FILE: P.I.# 0008680
Warren County / GDOT District 2 - Tennille
I-20 Frontage Road from East of CR21/Williams Creek Church Rd to
CR185/Cadley Rd - TIA - Phase II

SUBJECT: APPROVED REVISED CONCEPT REPORT

Revised Project Concept Report

Phase II of a frontage road project in Warren County extending west from Cadley Road/CR 185 for approximately 1.30 miles and ends in a cul-de-sac. The proposed project was originally a frontage road that connected Williams Creek Church Road/CR 21 to Cadley Road/CR 185.

1. Sketch map
2. Revised Alignment Layout
3. Typical Section

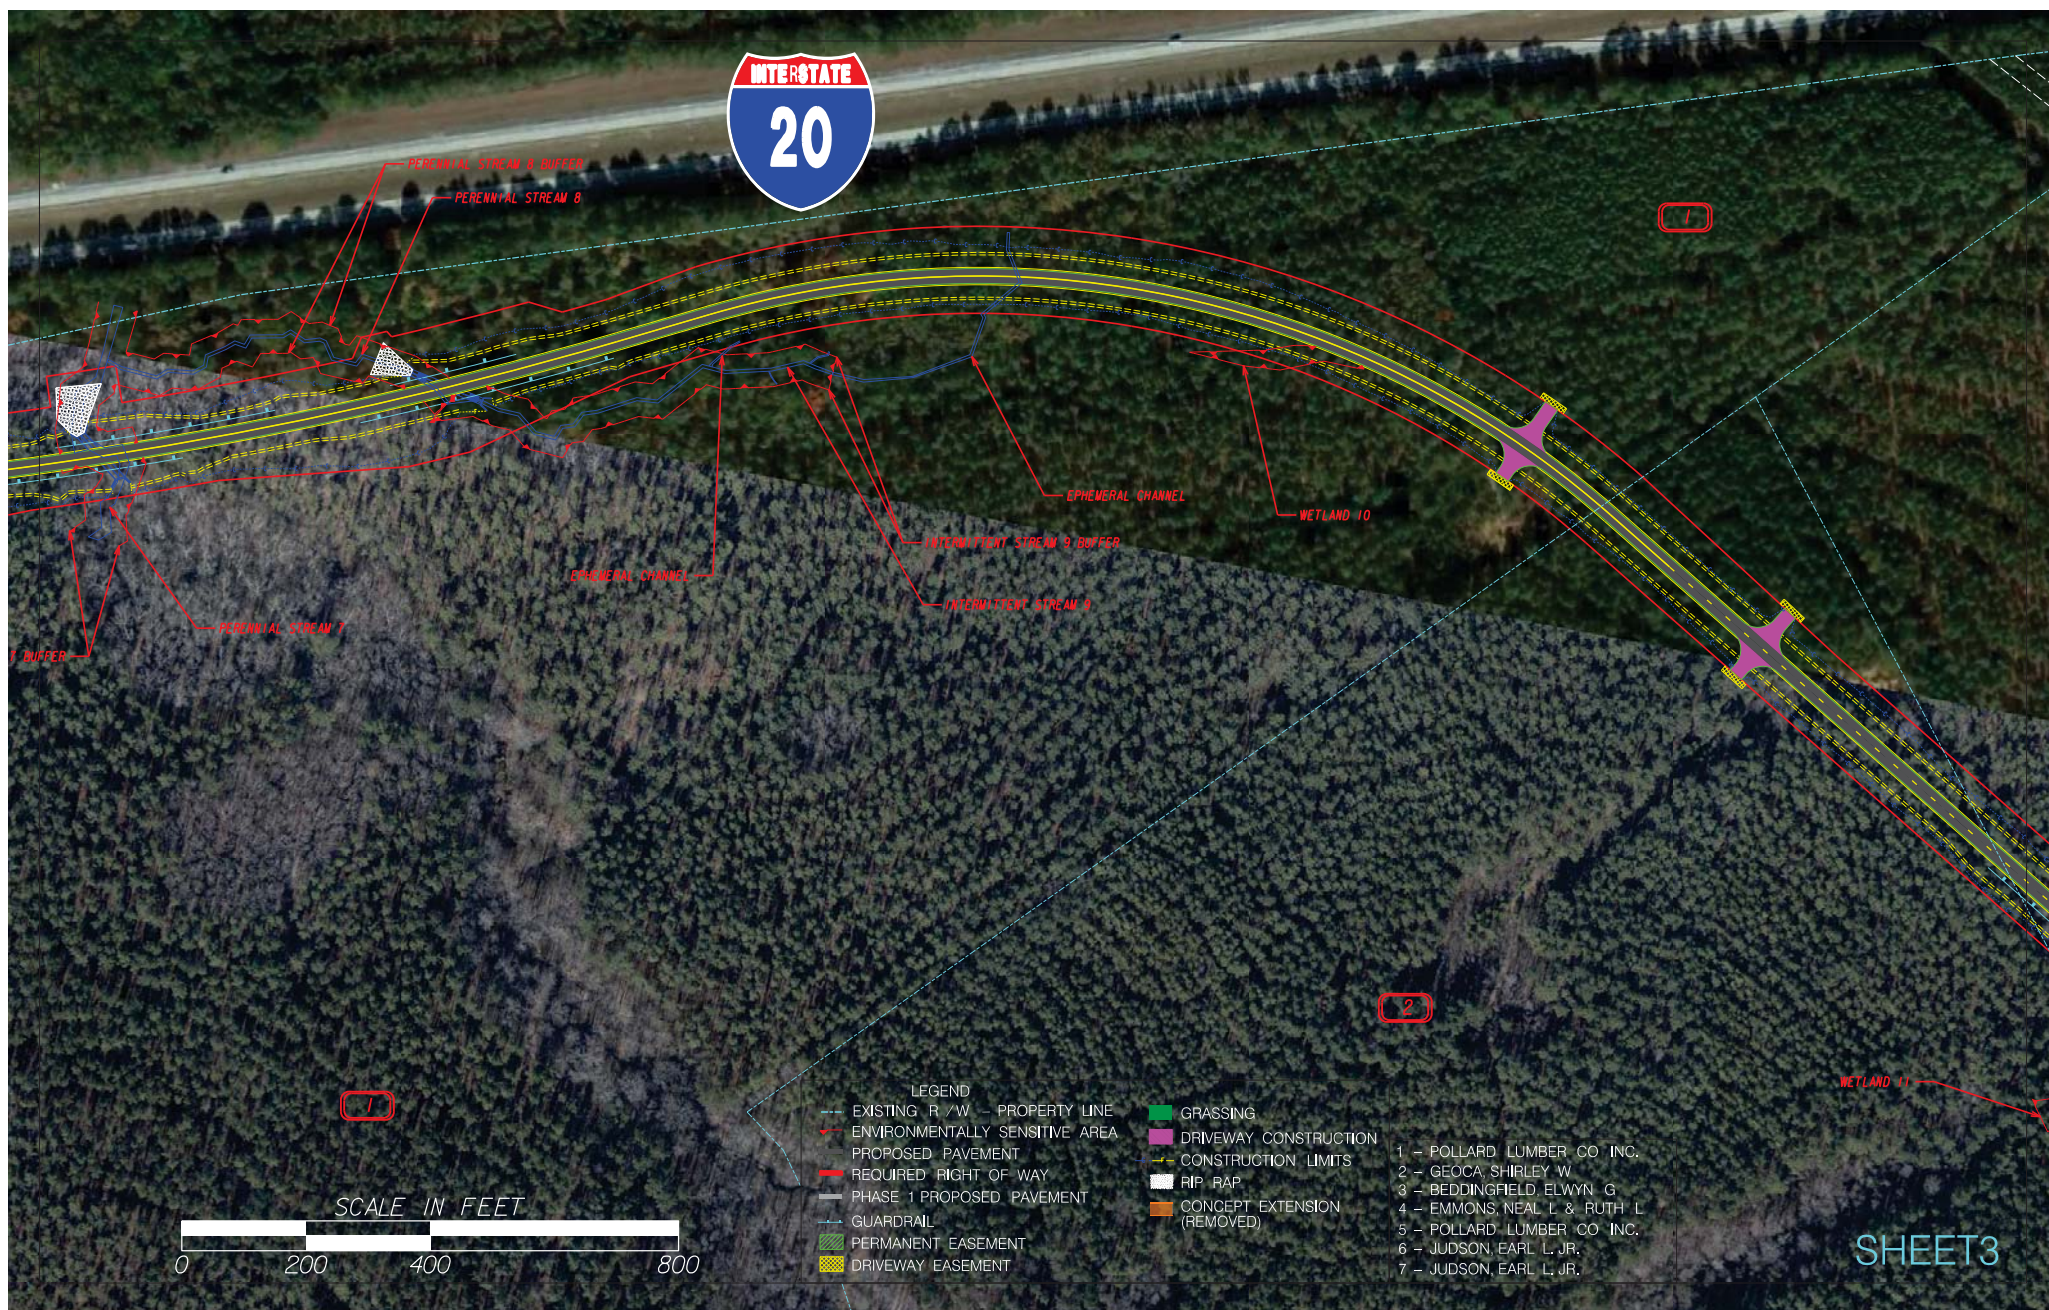
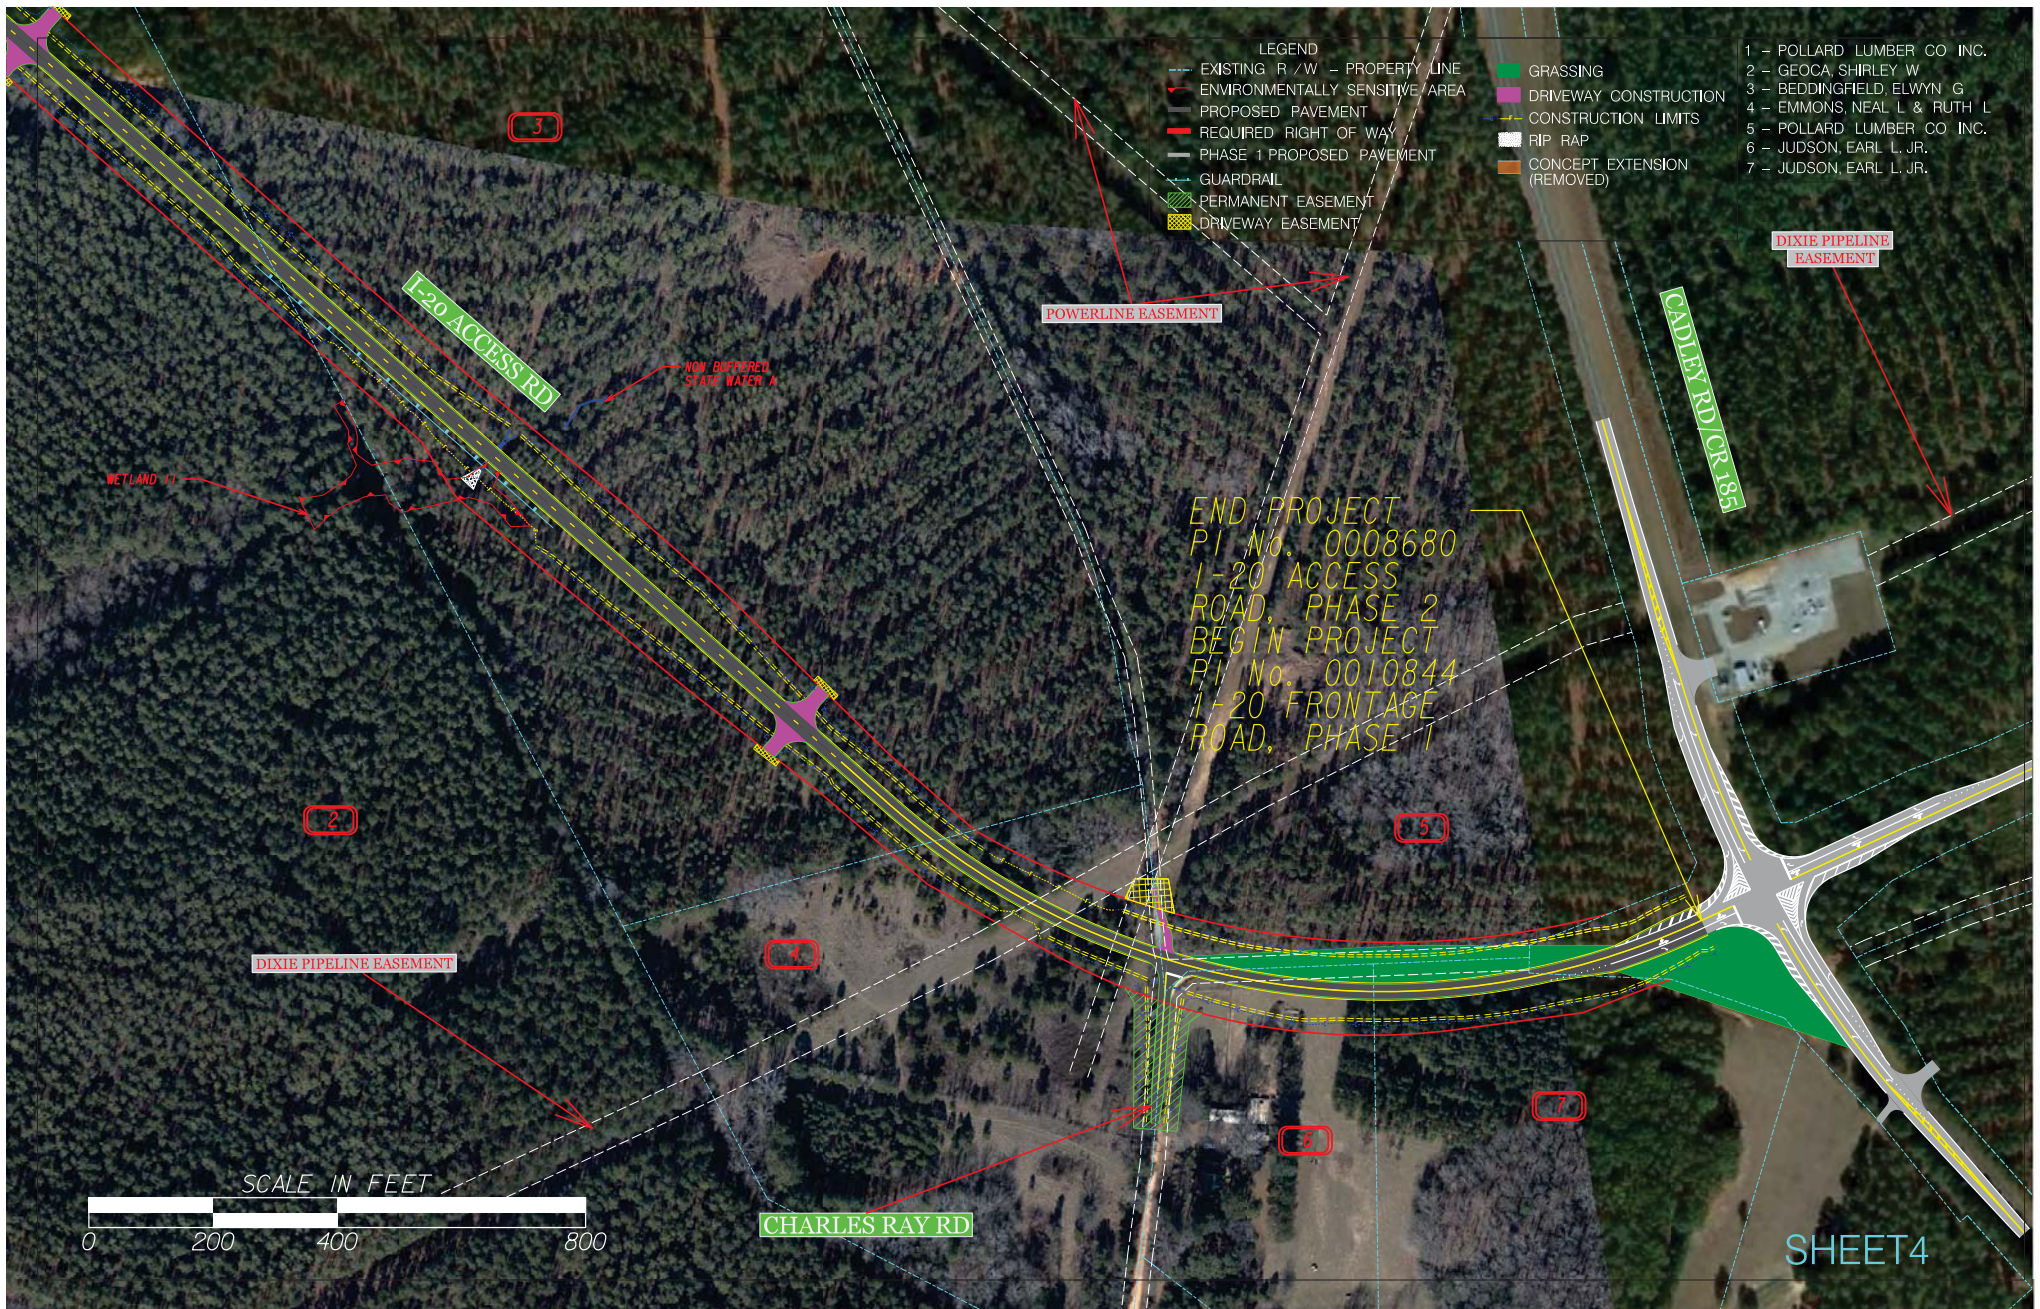
Other revisions to the proposed project include a change in road classification from a Rural Major Collector to a Rural Local Road, and the design speed will change from 55 mph to 45 mph.

Approved Features:	Proposed Features:
<ul style="list-style-type: none">Project Termini – The western terminus of the proposed project was at Williams Creek Church Road/CR 21 just south of I-20, the eastern terminus is just west of Cadley Rd/CR 185 at the previously completed intersection from the Phase 1 project (PI No. 0010844).Roadway Classification - Rural Major CollectorDesign Speed - 55 mph	<ul style="list-style-type: none">Project Termini – The western terminus is now a cul-de-sac located approximately 1.0 mile east of Williams Creek Church Road/CR 21 and Cadley Road/CR 185 just south of I-20, and the eastern terminus is just west of Cadley Rd/CR 185 at the previously completed intersection from the Phase 1 project (PI No. 0010844). The revised termini will shorten the proposed project length approximately 1-mile.Roadway Classification – Rural Local RoadDesign Speed – 45 mph
Reason(s) for change: Due to project budget, environmental impacts, and impacts of required ROW, the project is being revised to end with a cul-de-sac.
